This is to certify that Sarkisov Valeriy & /no contractor / self  
has permission to ammend permit # 05-1318 - add attach 26' x 30' garage and breezeway  
AT 129 Braintree St 333 H005001

**City of Portland, Maine - Building or Use Permit Application**

Past Use: single family	Proposed Use: single family - ammend permit # 05-1318 - build attached 26' x 36' garage and breezeway	Permit Fee: \$174.00	Cost of Work: \$17,000.00	CEO District: 5
Proposed Project Description: ammend permit # 05-1318 - build attached 26' x 36' garage and breezeway		FIRE DEPT: <input type="checkbox"/> Approved <input checked="" type="checkbox"/> Denied Signature: <i>[Signature]</i>	INSPECTION: Use Group: R-3 Type: 5B IRC 2003 Signature: <i>[Signature]</i>	
		PEDESTRIAN ACTIVITIES DISTRICT (P.A.D.) Action: <input type="checkbox"/> Approved <input type="checkbox"/> Approved w/Conditions <input type="checkbox"/> Denied Signature: _____ Date: _____

Cross section

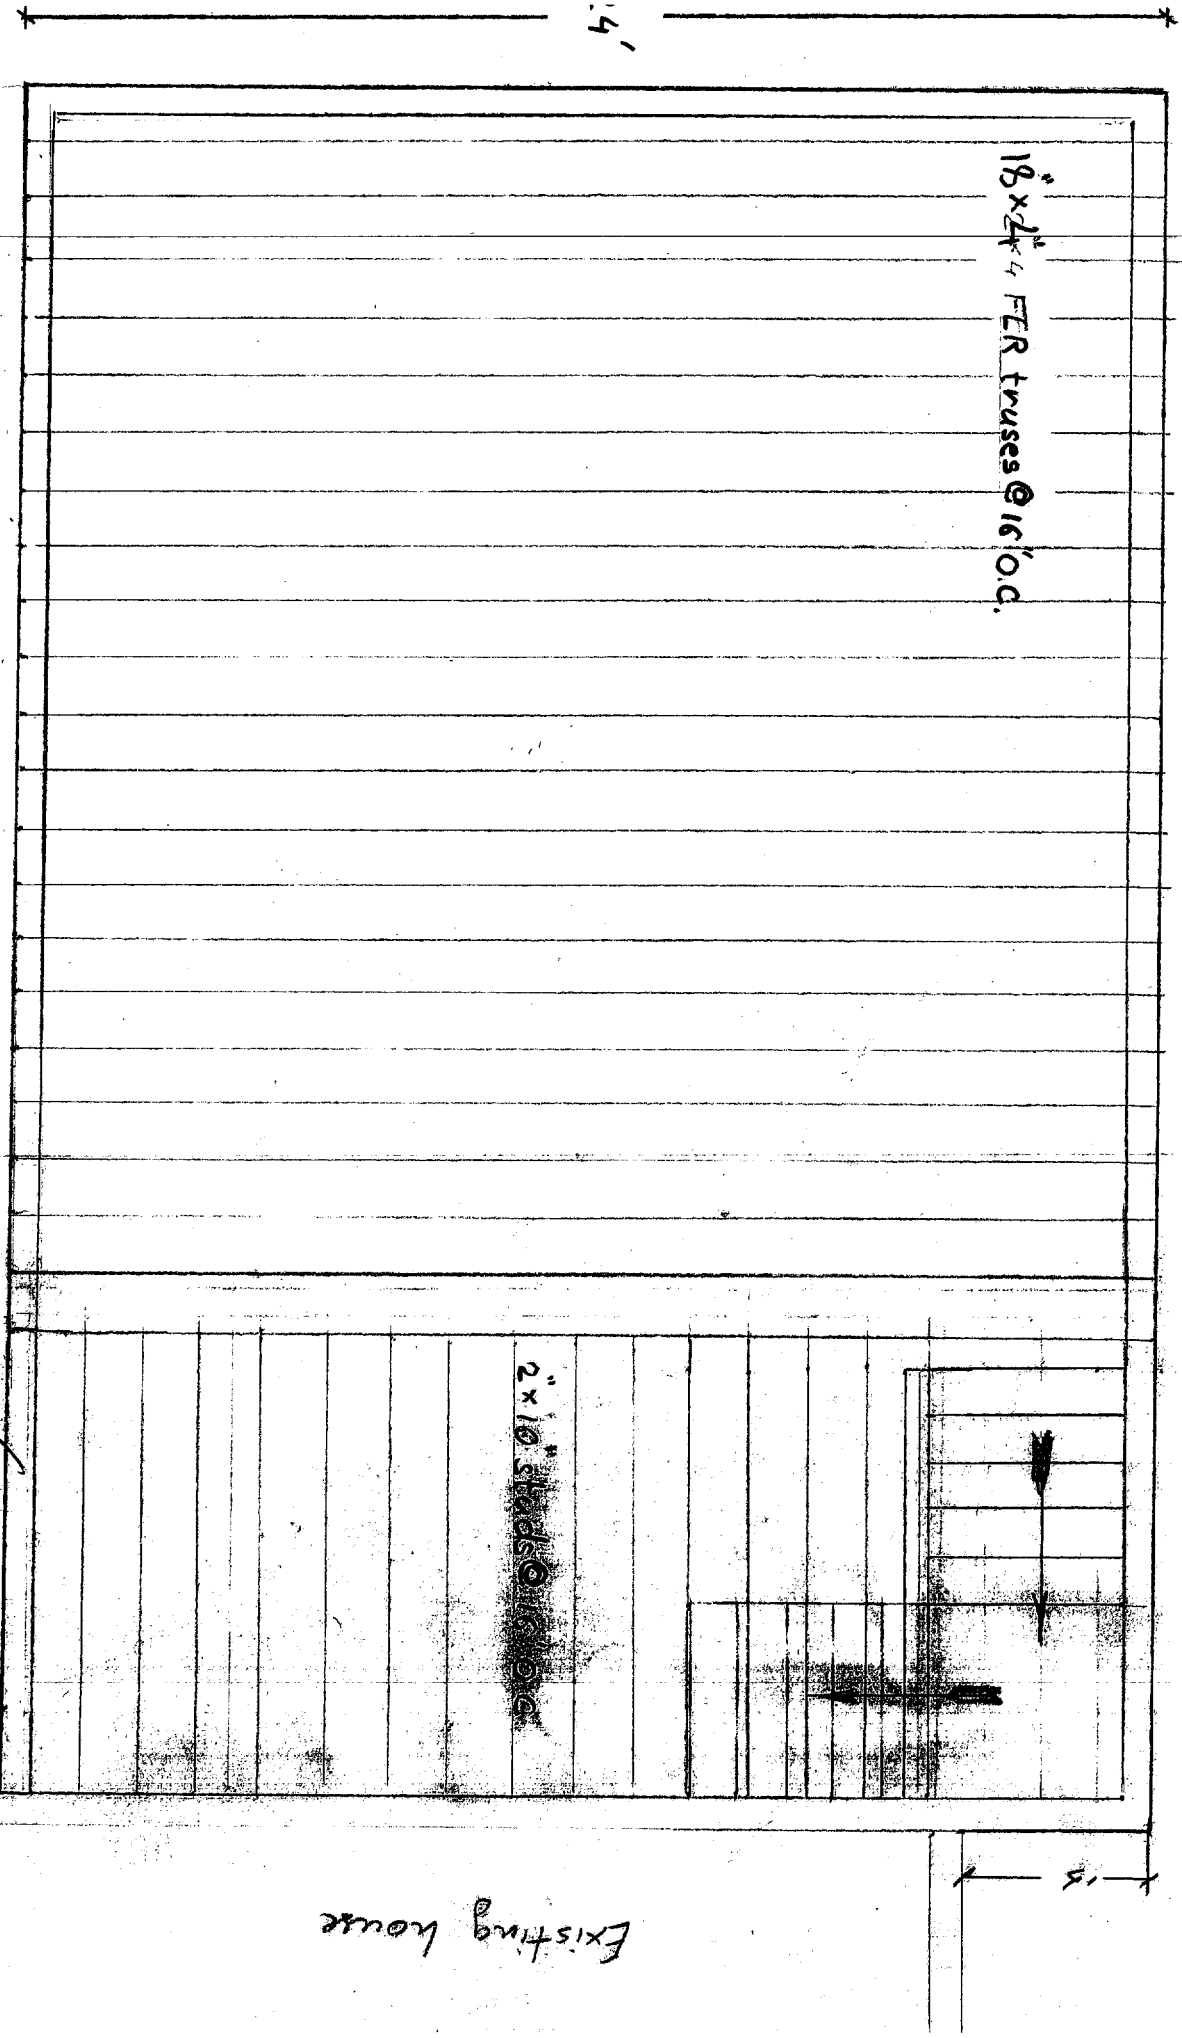
Beam size ?

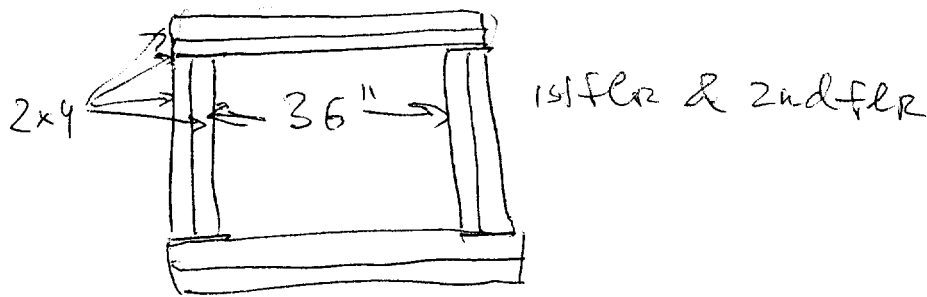
① Structural header sizes over all windows & doors.

② Structural beam size supporting 2nd floor over breezeway.

③ Stair detail for breezeway entry.

upstairs 3 2x6 over ~~upstairs~~  
over windows 1st flr  
& 36x54 win 2nd flr

**Triple 1 3/4" x 9 1/4" VERSA-LAM® 2.0 3100 SP**
